City of Ketchum

Recommendation To Approve Change Order #5 to Contract 20454

Project Description: Fire Station CM/GC

Change Order #:005

M1.01

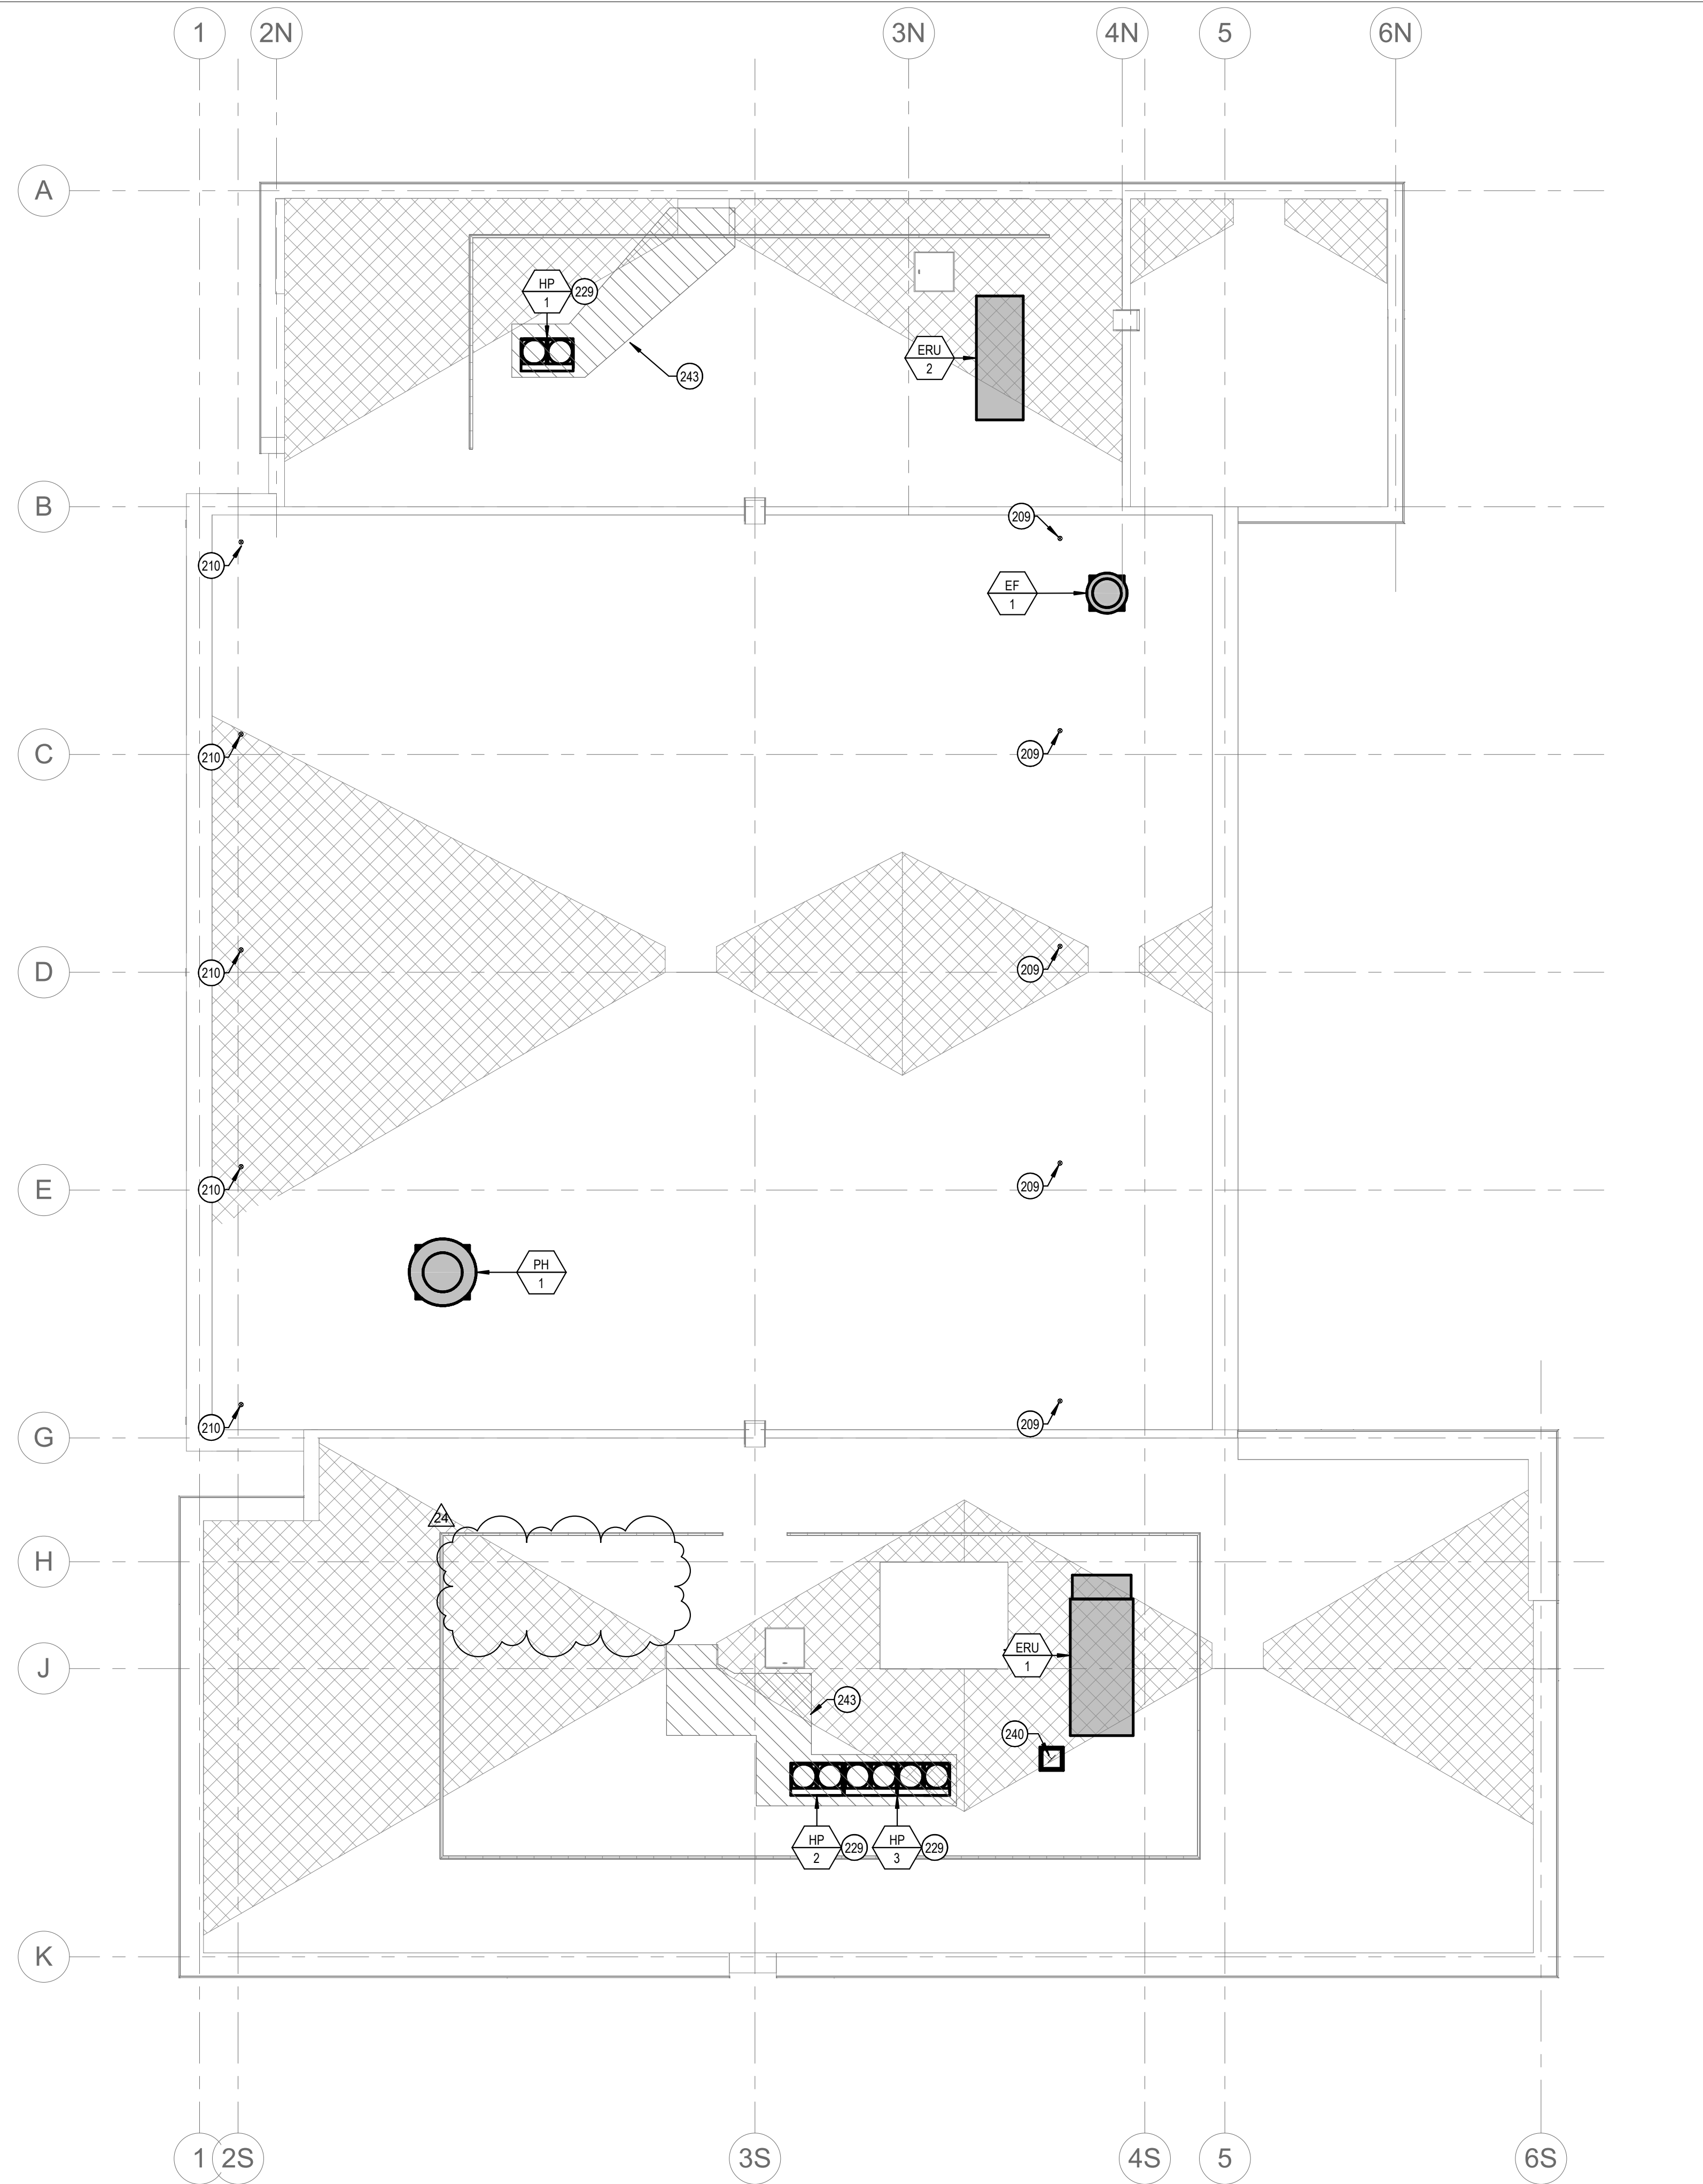
The owner is opting to remove the redundancy of fan coil units in the IT rooms. Please confirm the equipment that is to be removed from the scope of the project so that a credit can be provided. IT 109 has FC 112 fed from the VRF and DFC/DCU 1. IT Room 217 has FC 210 fed from the VRF and DFC/DCU 2.

1. M1.00 – HVAC PLAN- LEVEL 01
 - a. Removed DFC-1 and associated thermostat.
2. M1.01 – HVAC PLAN- LEVEL 02
 - a. Removed DFC-2 and associated thermostat.
3. M1.04 – HVAC ROOF PLAN
 - a. Removed DCU-1 and DCU-2.
 - b. Removed keyed note 230.
4. M4.00– HVAC SCHEDULES
 - a. Removed Ductless Split System Air Conditioning Unit Schedule.

KITCHEN/DAY USE LOCKER LAYOUT
 INTERIOR ELEVATION
 RFI #CC-167
 KETCHUM FIRE STATION #1
 4/21/21

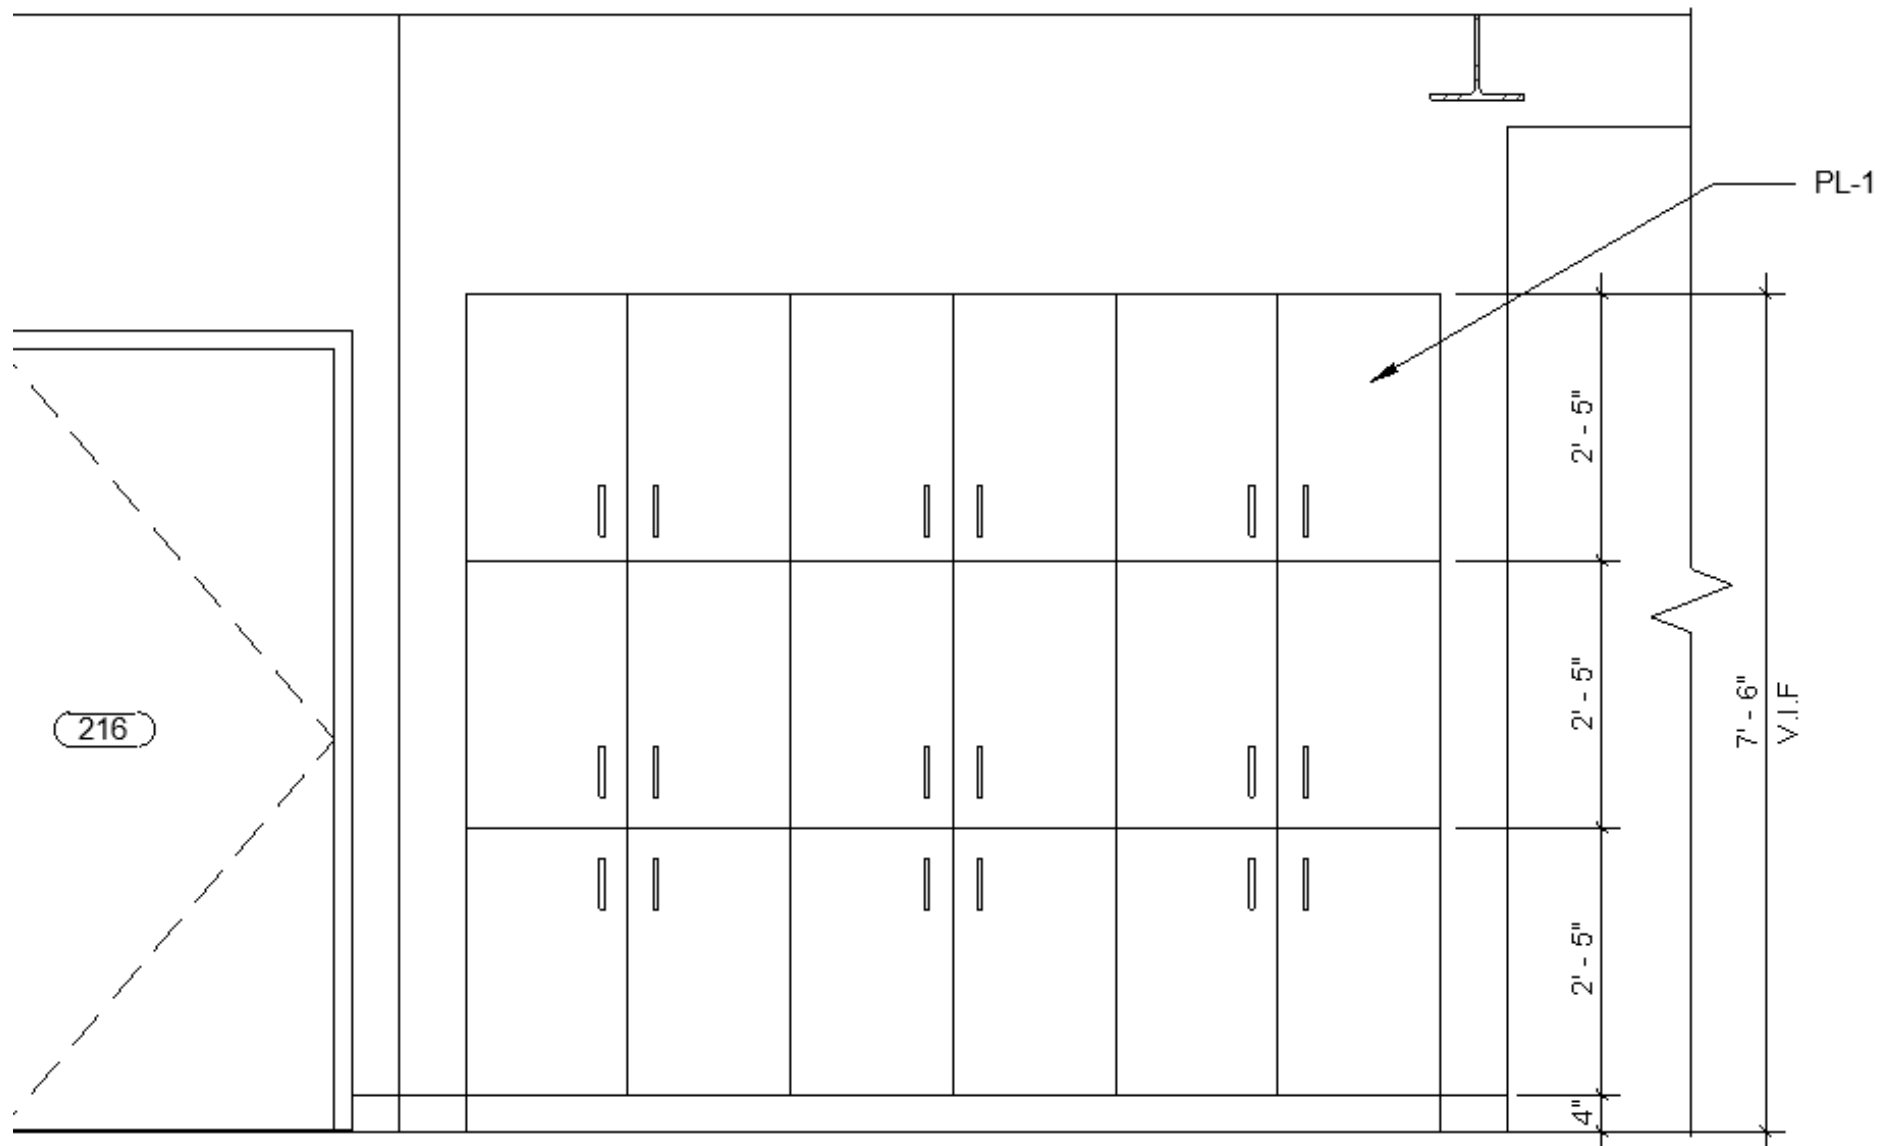
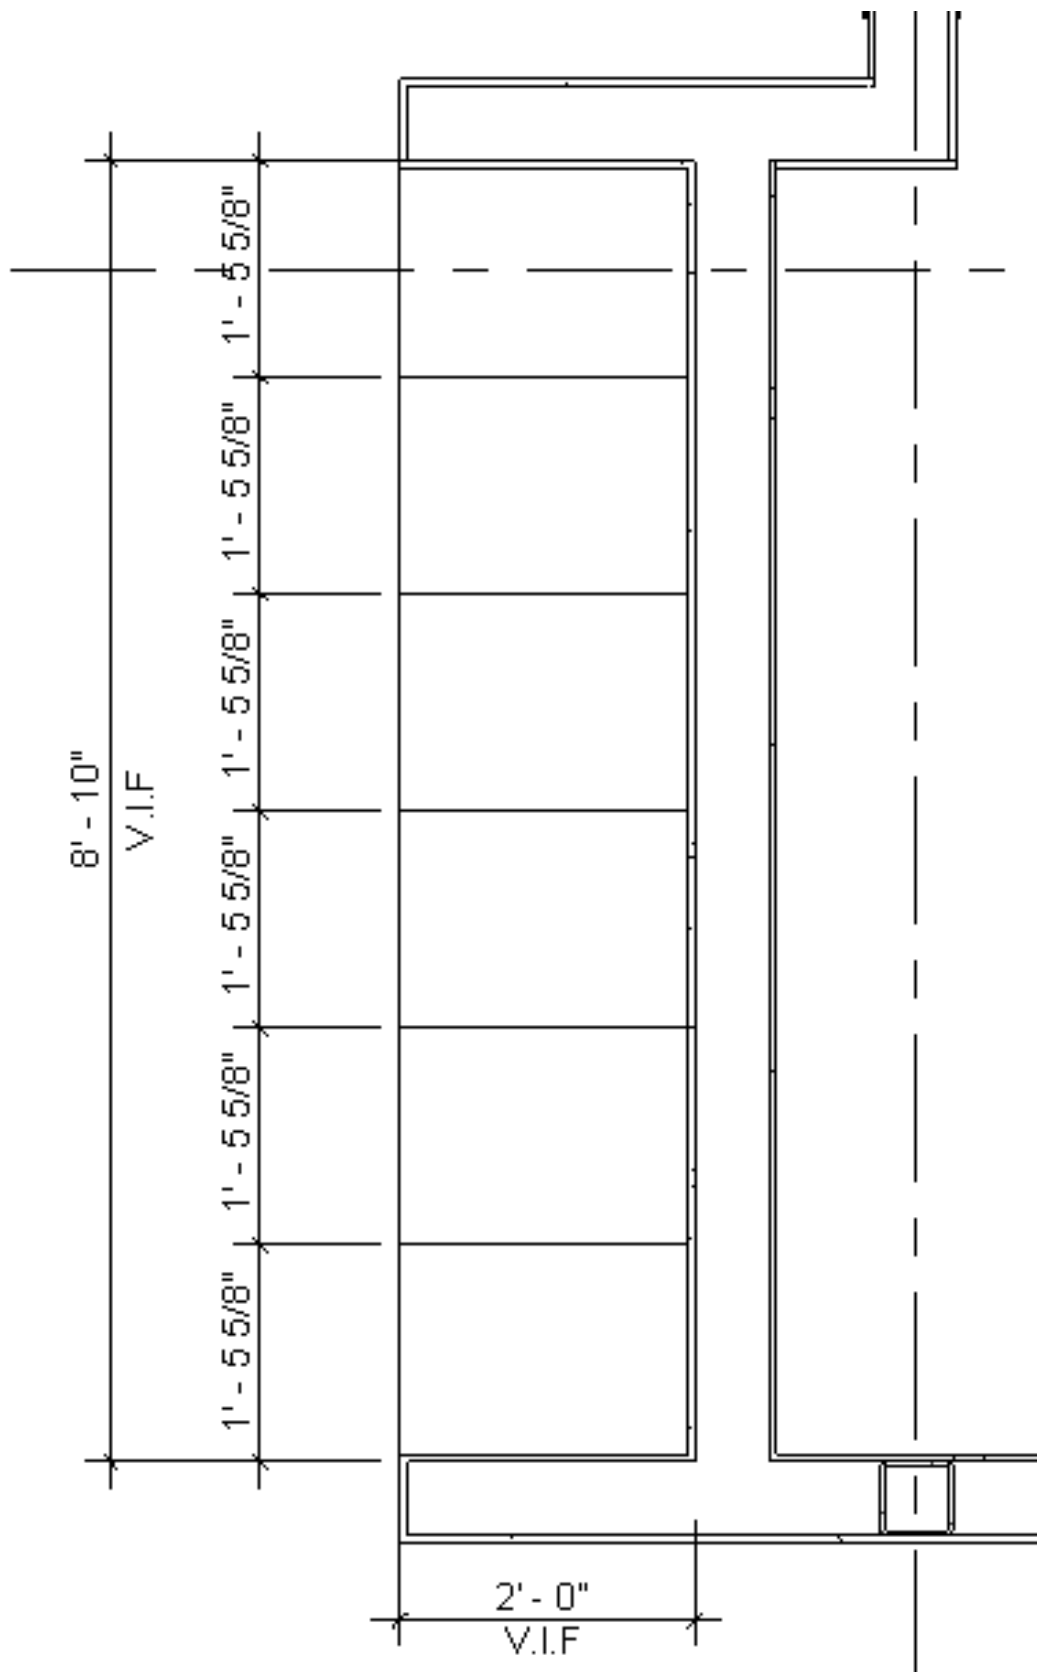
As discussed, the metal lockers shown in the Day Use Room 201 detail 2/A5.02 are to be changed to Plastic Laminate. Please confirm layout and finish for the plastic laminate.

Lockers to be PL-1.

Each of the 18 lockers to have a keyed lock.

Cabinet pulls to match other Kitchen casework.

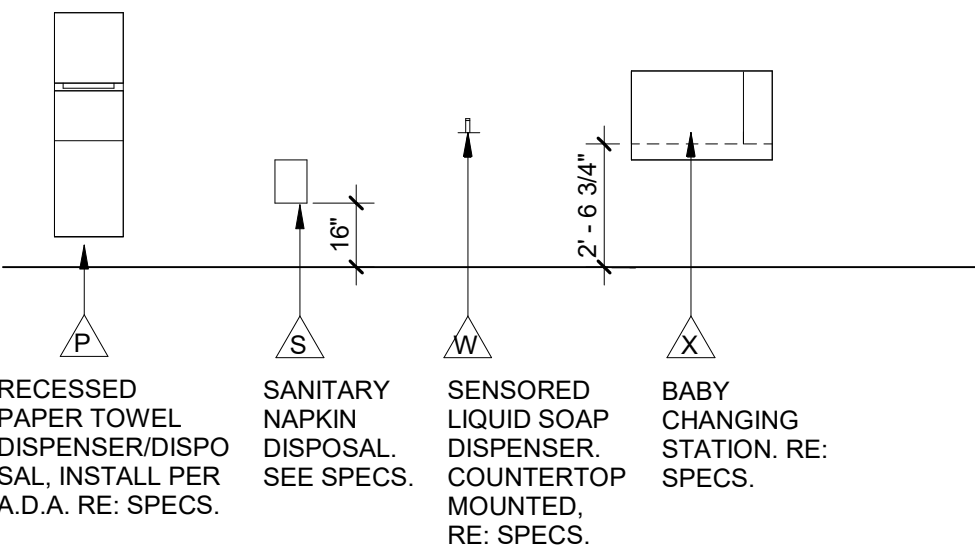
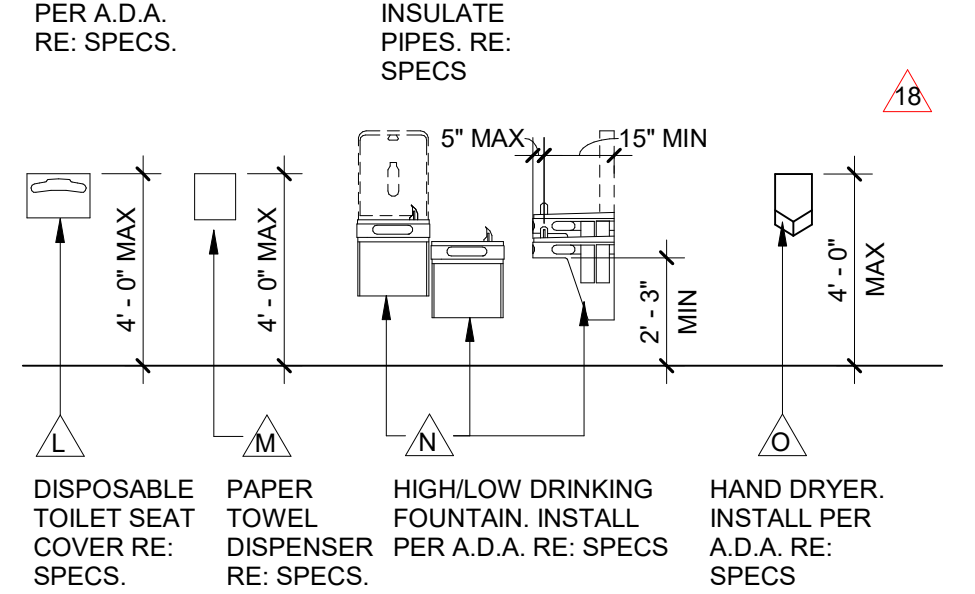
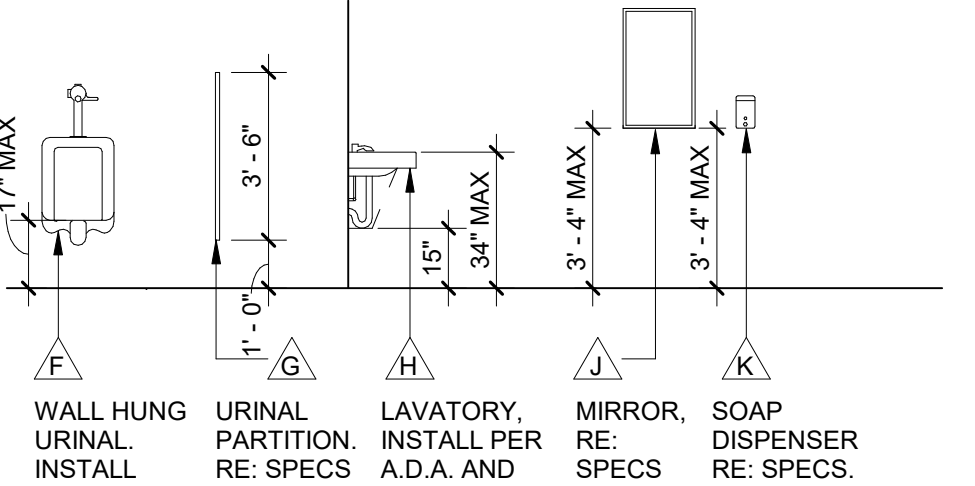
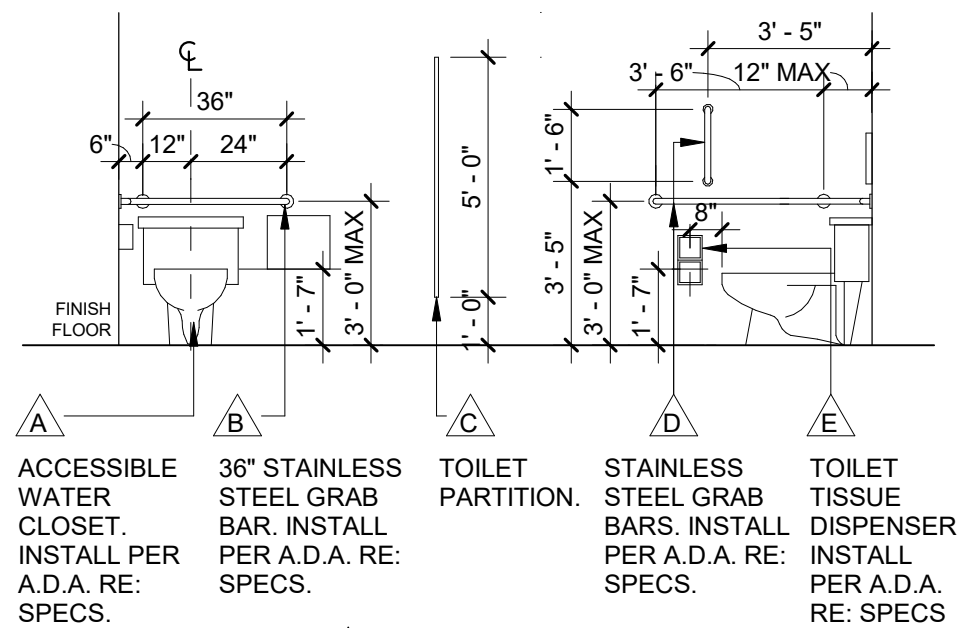
See attached updated sheet A5.00 - INTERIOR ELEVATIONS - RESTROOMS.

- #20 - SHOWER 214 - EAST
 - Removed recessed paper towel dispenser (Bobrick - model # B-35903).
- #21 - SHOWER 214 - SOUTH
 - Added recessed paper towel dispenser (Bobrick - model # B-35903).
